# Planning Report

## Midwestern Auto Group PUD – Subarea C

### Case Summary

<p>City of Dublin</p>	<p>16-017FDP Final Development Plan MAG - Jaguar/Land Rover 6335 Perimeter Loop Road</p>	<p>0 200 400 Feet</p> 
---	--	---

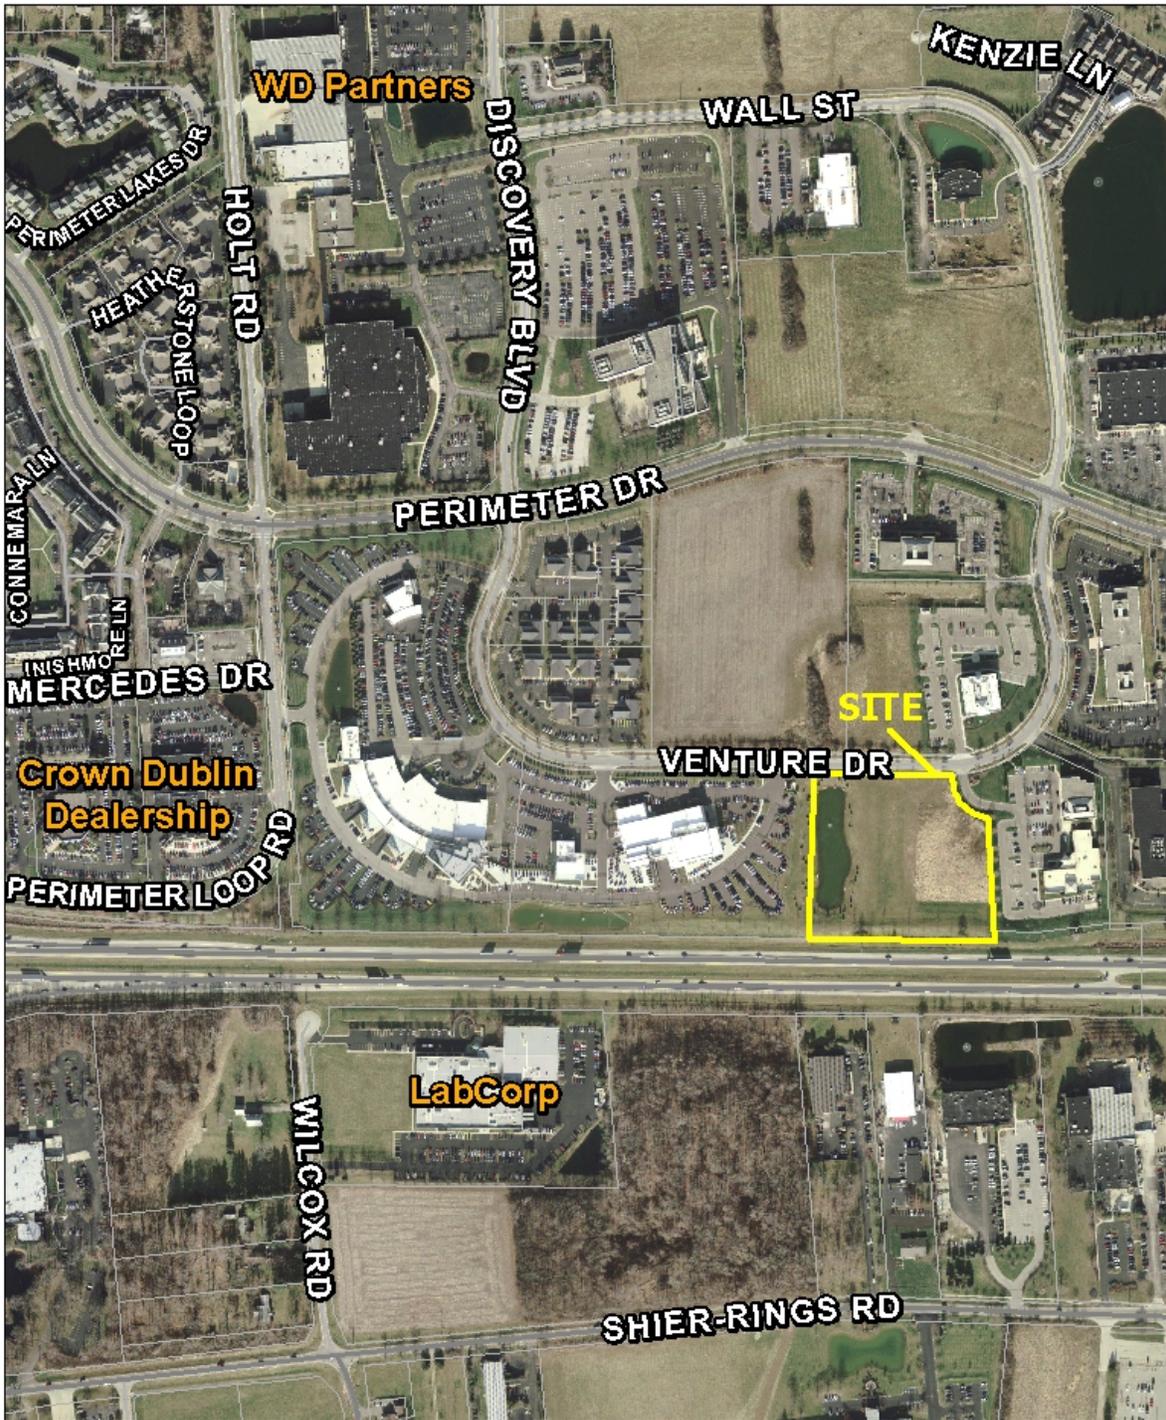
- 1) That the applicant pay a fee in lieu of tree replacement prior to filing for building permitting;
- 2) That the applicant revise the landscape plans to include deciduous trees every forty feet adjacent to the east property line prior to filing for building permitting;
- 3) That the applicant provide a 4:1 maximum slope along the west edge of the proposed retention basin as well as a flat buffer zone between the drive aisle and top of bank of the retention basin;
- 4) That the applicant provide details for the proposed location and construction of the landscaping wall, in the event a retaining wall is required around the retention basin, subject to Staff approval; and,
- 5) That the applicant continue to work with Engineering to meet all stormwater management requirements outlined in Chapter 53.
